Headlight Dimmer Relay Replacement Instructions

VW PN 111-941-583

Beetle and Karmann Ghia Models 67-71

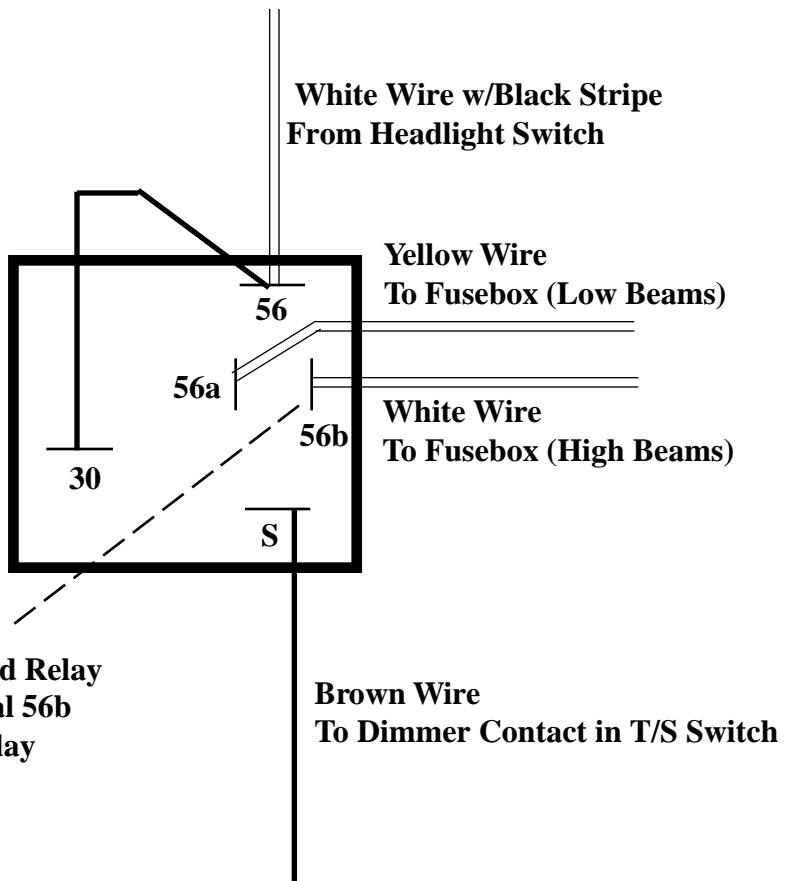
Wire Bridge
Between Terminals
56 & 30
(Factory Spec - Required when
replacing on 67-71 Models)

NOTE:
Terminal F on Old Relay
is now Terminal 56b
on NEW Relay
